# Naval Research Laboratory

NRL/MR/7441--94-7516

## Digital Mapping, Charting, and Geodesy Analysis Program Technical Review of Vector Smart Map Prototypes 1 and 2

January 19, 1995

Figure 8 Water courses with apparent gaps

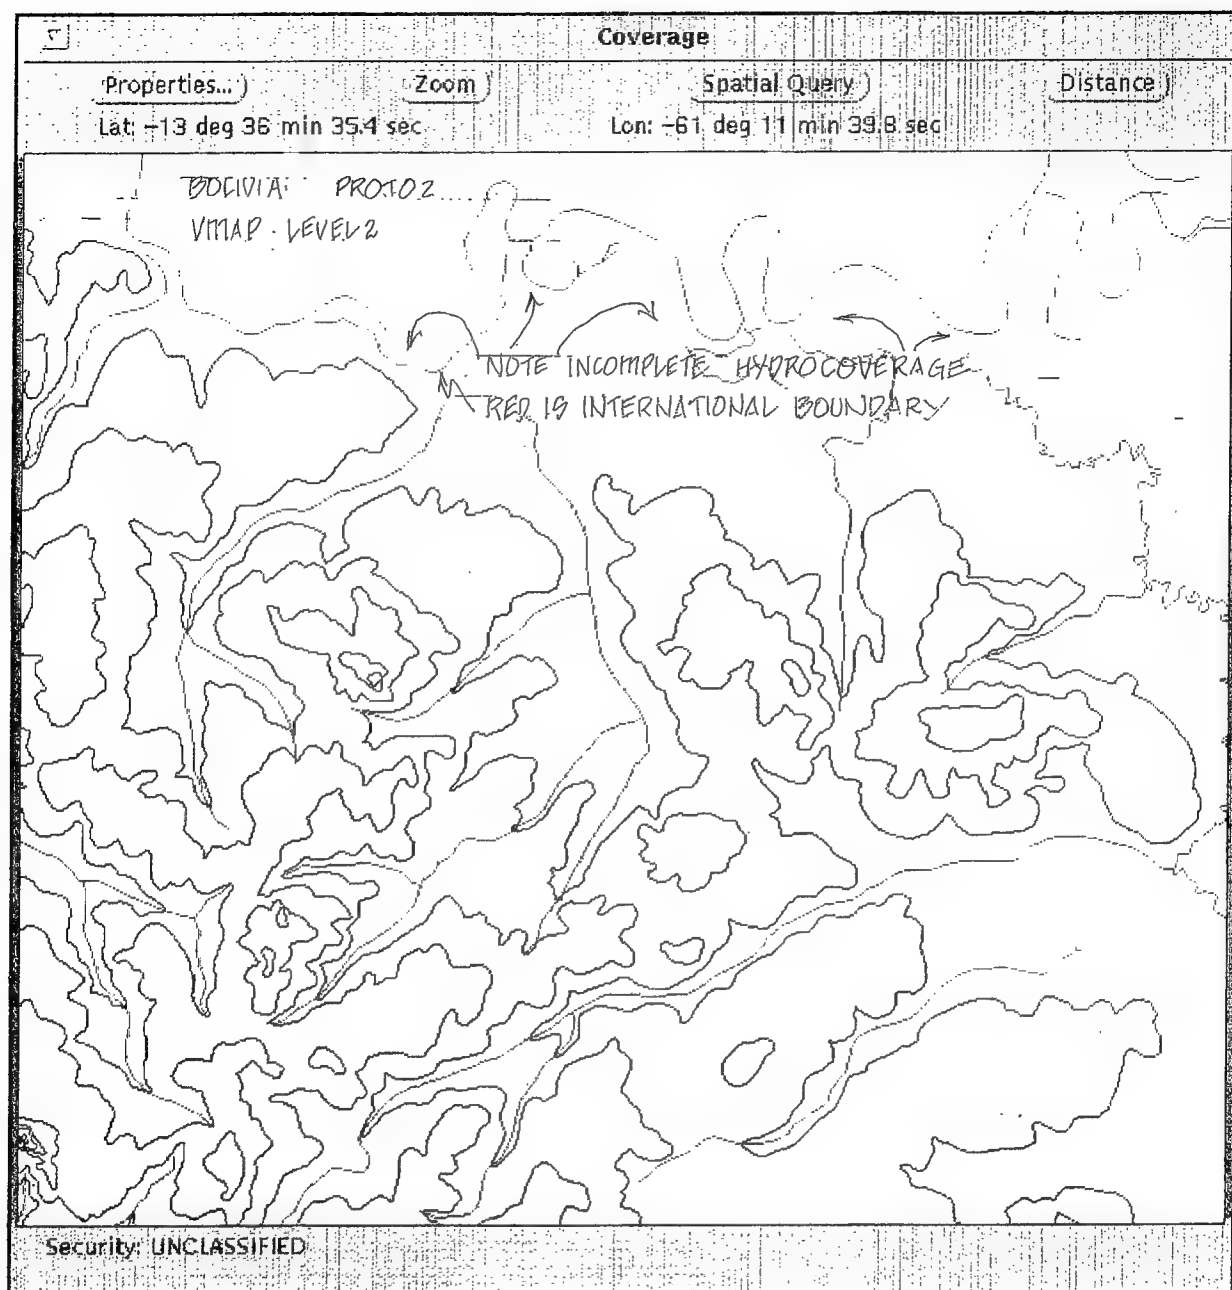
Figure 8 displays the water courses in the Hydrography coverage and political boundaries in the Boundaries coverage of the high resolution Bolivia data. Similar to the Level 1 Bolivia database, confusion resulted near the boundary. Water courses appear incomplete, when in actuality the area feature class Water Courses and Bodies "fill-in" the gaps.

Figure 9a. Construction of a query using Microsoft Access QBE editor

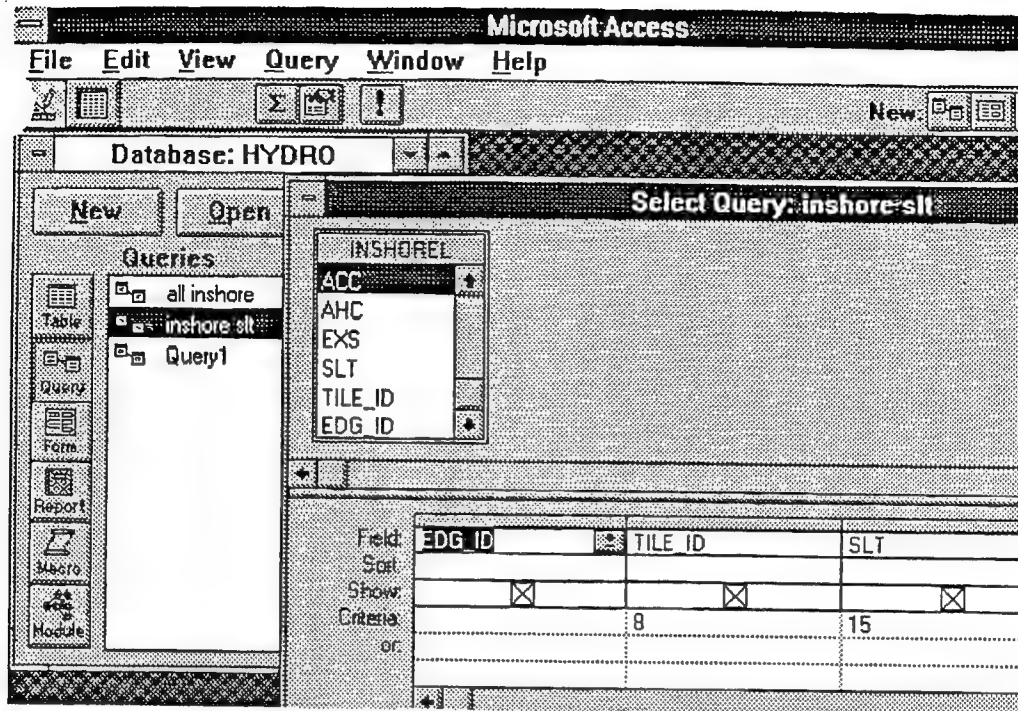
Figure 9a shows the construction of a query using Microsoft Access Query By Example (QBE) editor. The query accesses a single table, the Inland Shore Line Feature Table in the Hydrography Coverage, and is designed to list the EDG\_IDs that are in TILE\_ID 8 that have a Shoreline Type Category of "Other" (attribute value 15). Figure 9b is the spreadsheet view of the result of the query. It was noted that all of the rows in this table have a value of "Other" in the Shoreline Type Category. If none of the shorelines fit any of the categories, then either the categories are poorly chosen or the data were carelessly produced.

Figure 12. Overlay of  $V_{Map}$  and ITD built-up area features

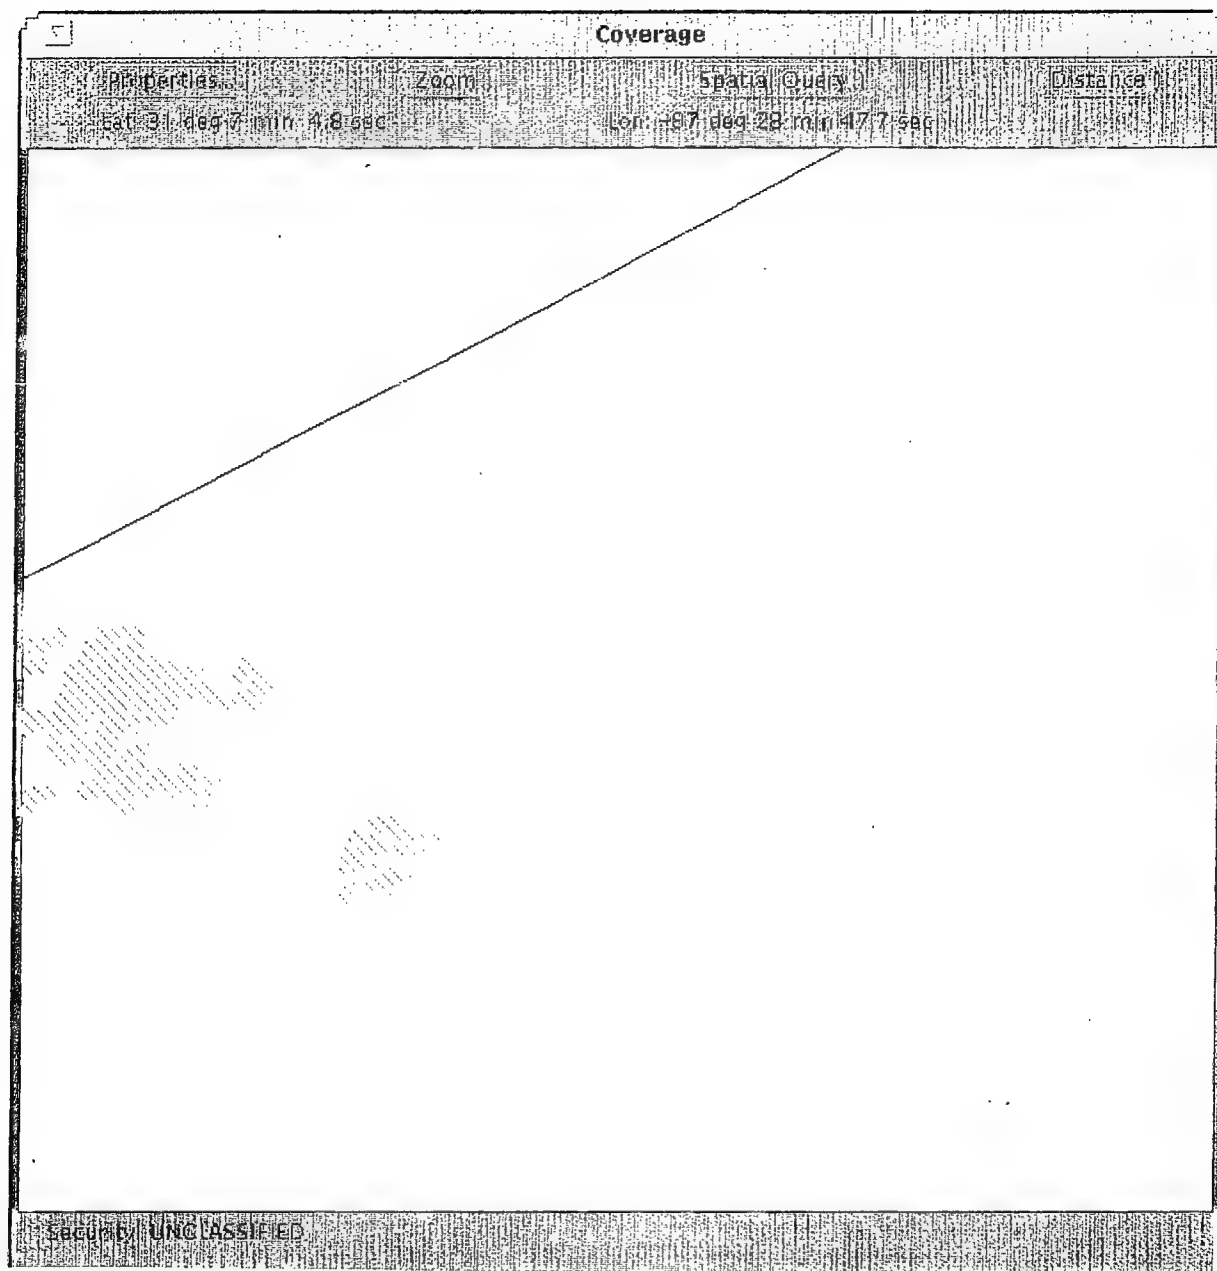
Figure 12 is an overlay of the Built-up Area (AL020) features in ITD and  $V_{Map}$ . ITD is represented in yellow and  $V_{Map}$  in diagonal red stripes. As can be seen, the Built-up areas in ITD are more extensive than in  $V_{Map}$ . This may be due to the different levels of attribution in each database. In ITD, Built-up Area has no attributes, but in  $V_{Map}$  it can be categorized by density. All of the Built-up Areas appearing in  $V_{Map}$  are classified as "Dense." The following question arises: Will  $V_{Map}$  contain only "dense" Built-up Areas, or were these the only Built-up Areas digitized for this particular implementation of  $V_{Map}$ ? In either case, assuming that ITD is correct, the remaining areas need to be added to  $V_{Map}$ .

Figure 14. Road/bridge discrepancies between  $V_{Map}$  and ITD

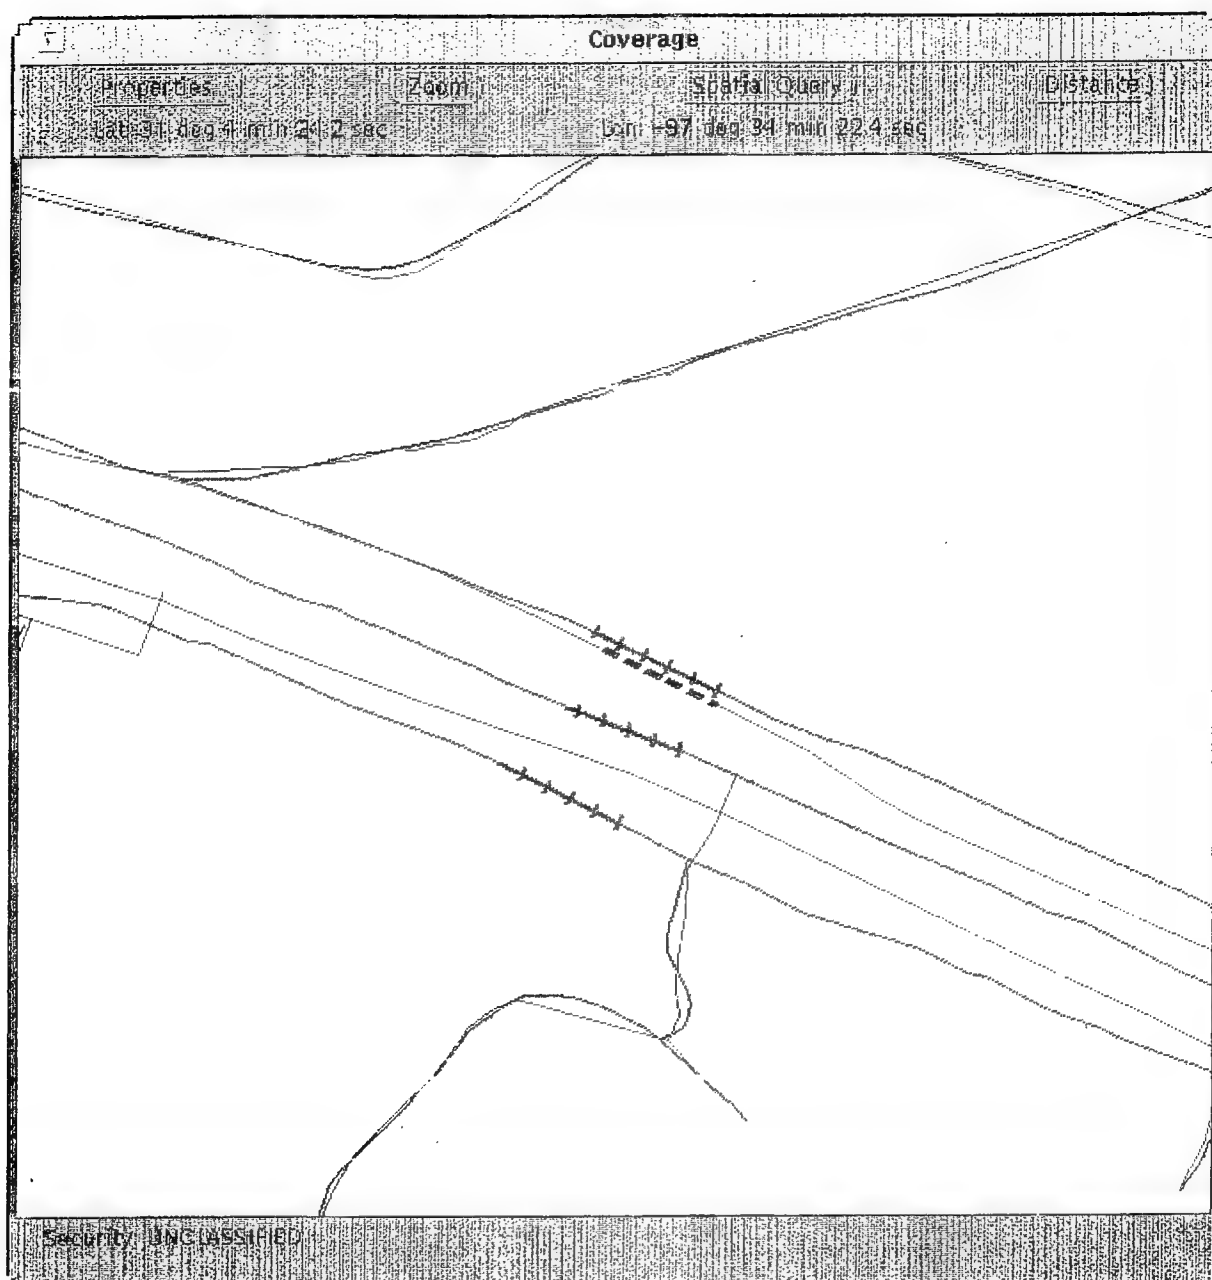
Figure 14 uses the same color scheme as Figure 13. In Figure 14 a section of highway is shown by ITD to have three bridges, but only one by  $V_{Map}$ . Also evident in this figure is the lack of agreement on the placement and shape of ITD and  $V_{Map}$  features. There is a constant offset between ITD and  $V_{Map}$  of .02 to .03 mi (106 to 158 feet) for all features in all coverages.

Figure 15. River/stream discrepancies between  $V_{Map}$  and ITD

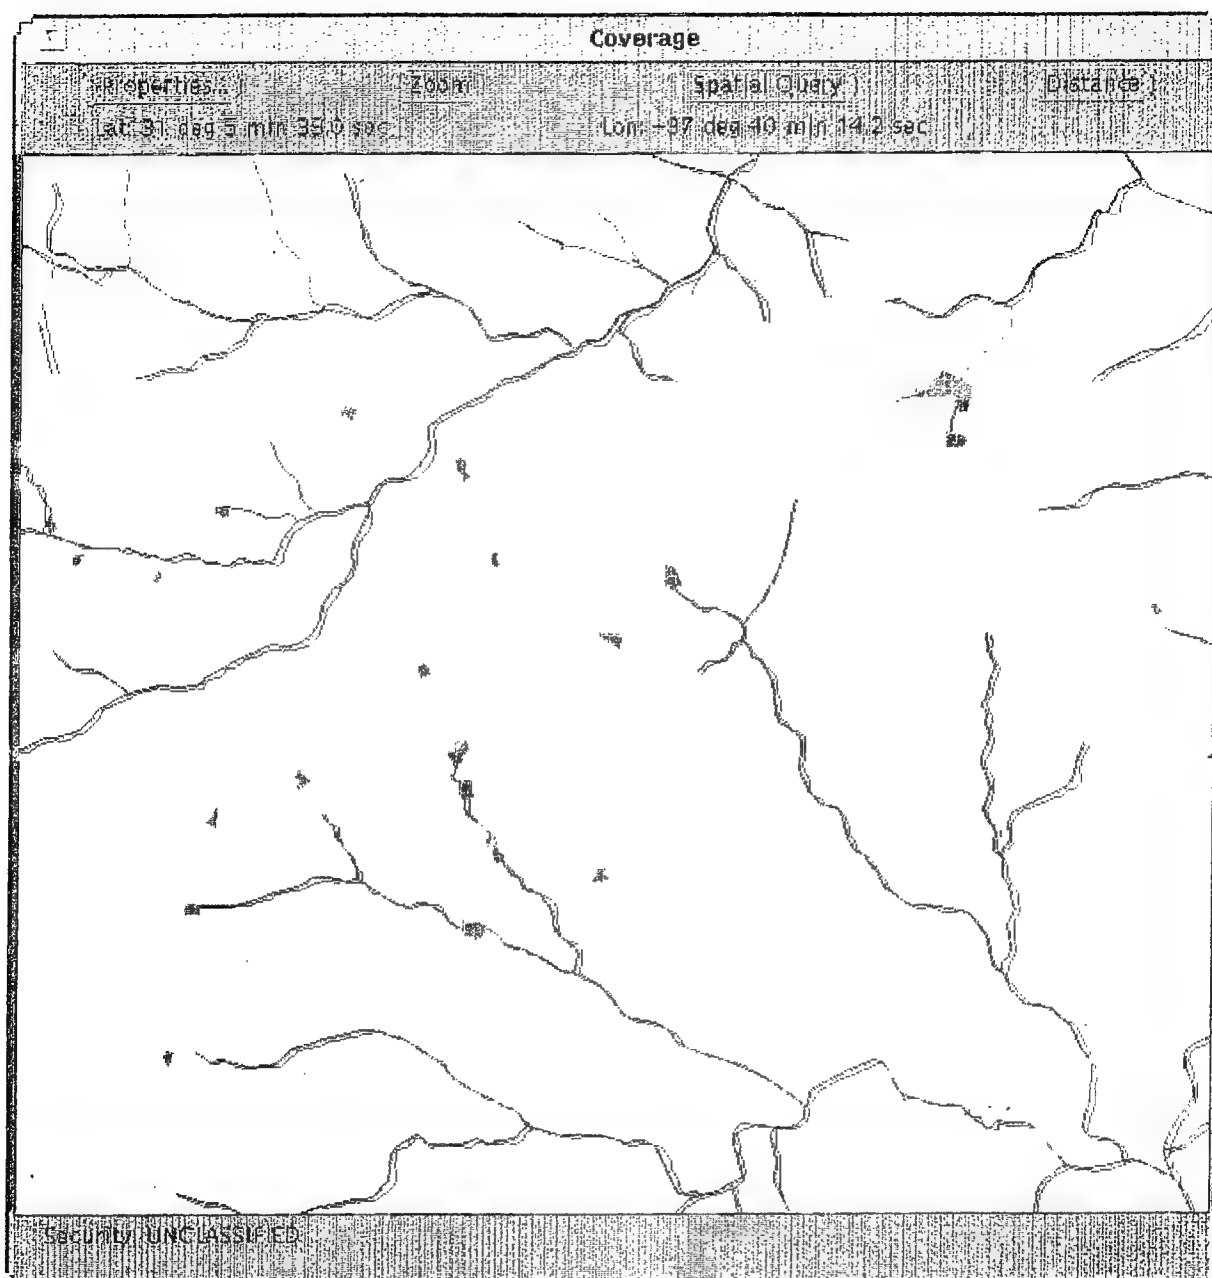
Figure 15 shows ITD River/Stream (BH140) line features in blue,  $V_{Map}$  River/Stream line features in red,  $V_{Map}$  Lakes/Ponds (BH080) in blue, and ITD Common Open Water (SA010) in orange. Of importance in this figure are the small Lakes/Ponds that are omitted from ITD and the various small river branches that are included by one database and not the other.

Figure 16. Reservoir classification disagreement between  $V_{Map}$  and ITD

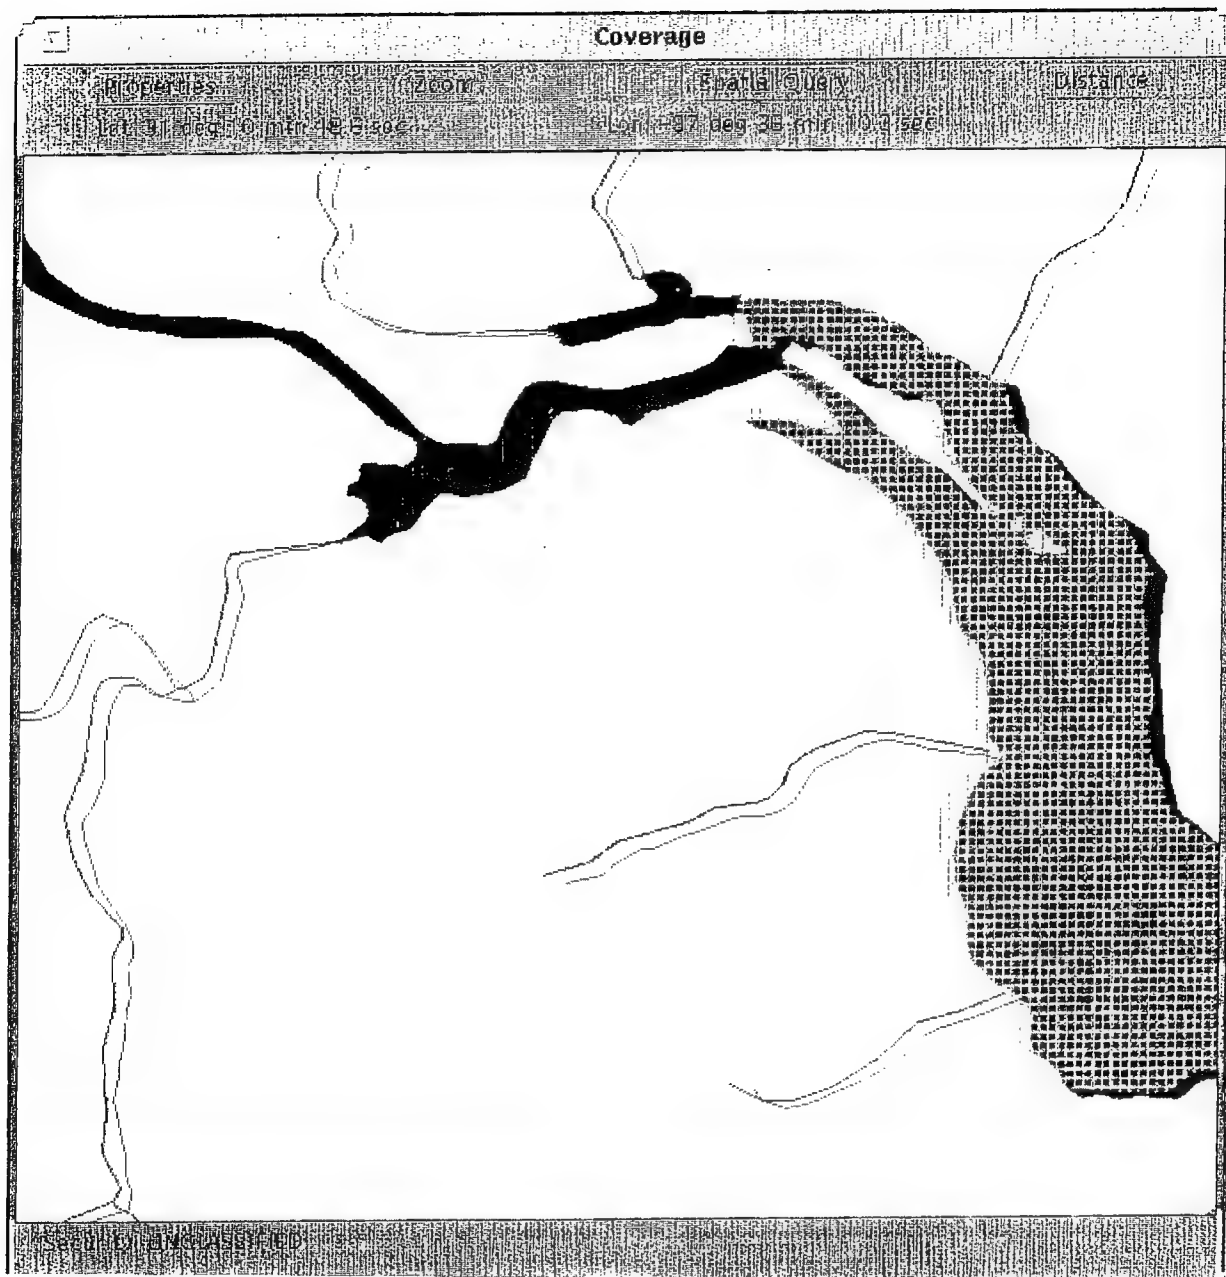
In addition to the features and color scheme of Figure 15, Figure 16 includes ITD River/Stream area features in dark blue,  $V_{Map}$  River/Stream area features in red, and Reservoir (BH130) in medium blue. This figure shows a disagreement on the classification of the extreme western end of the reservoir. ITD classifies it as both a river line and area feature, while  $V_{Map}$  labels it an extension of the reservoir area feature.

Figure 17. Ford differences between  $V_{Map}$  and ITD

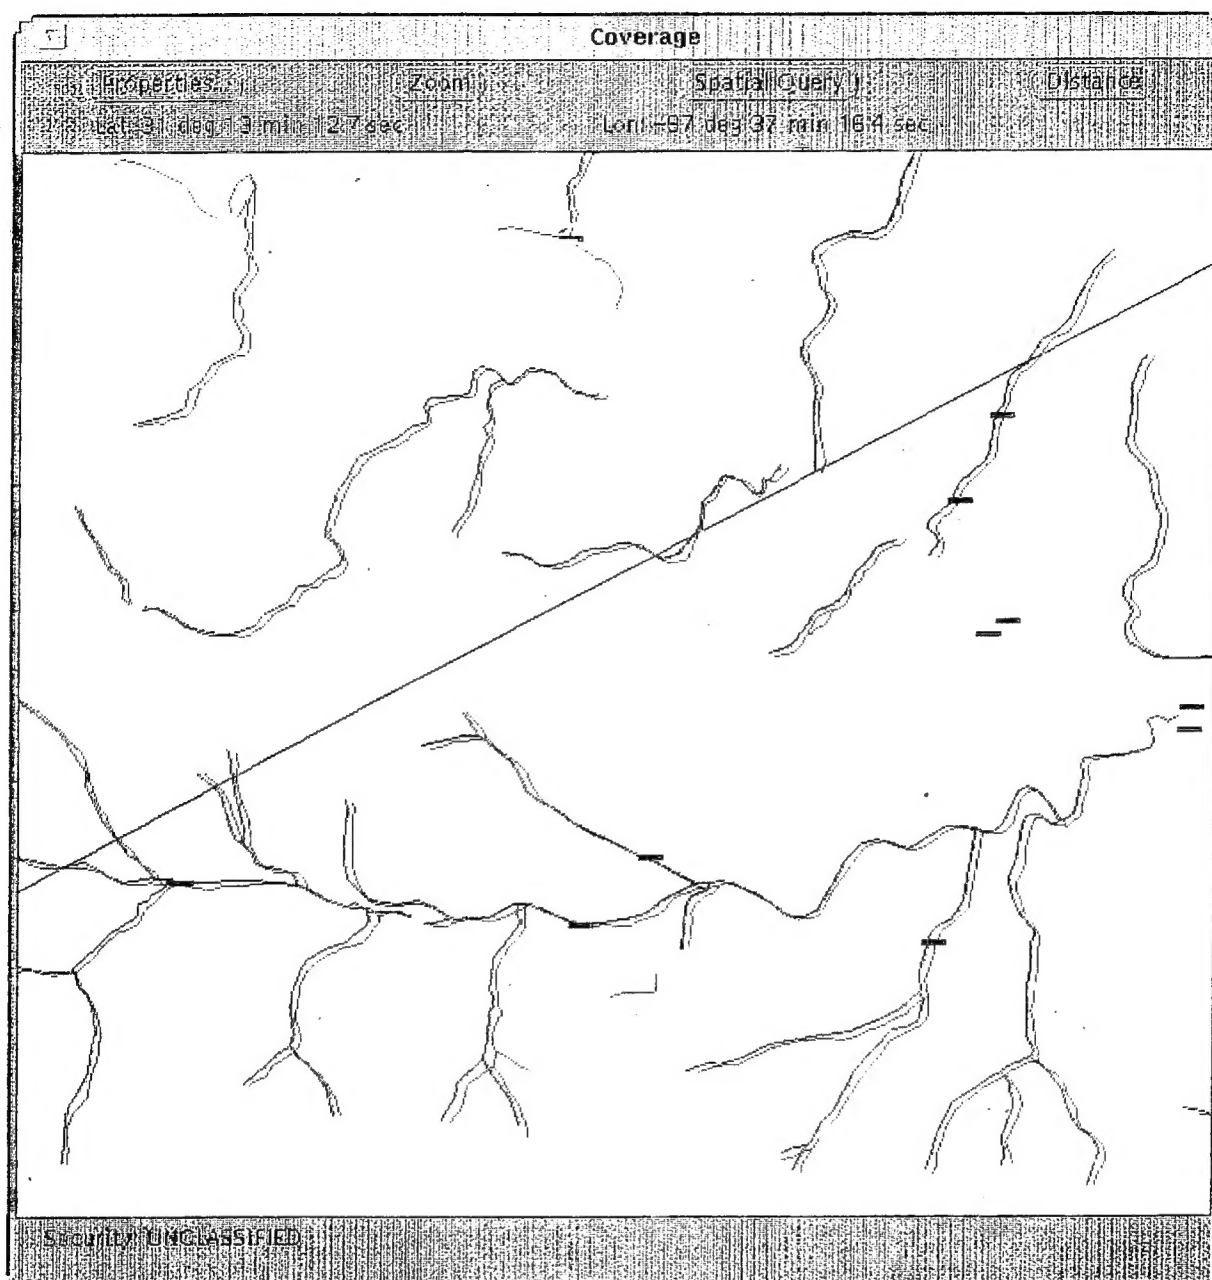
Figure 17 shows ITD Rivers/Streams (BH140) in blue,  $V_{Map}$  Rivers/Streams in red, ITD Fords (BH070) in gold, and  $V_{Map}$  Fords in black. In this figure, there is disagreement between the number and location of fords in the figure. In addition, the ITD fords are not on the ITD river.
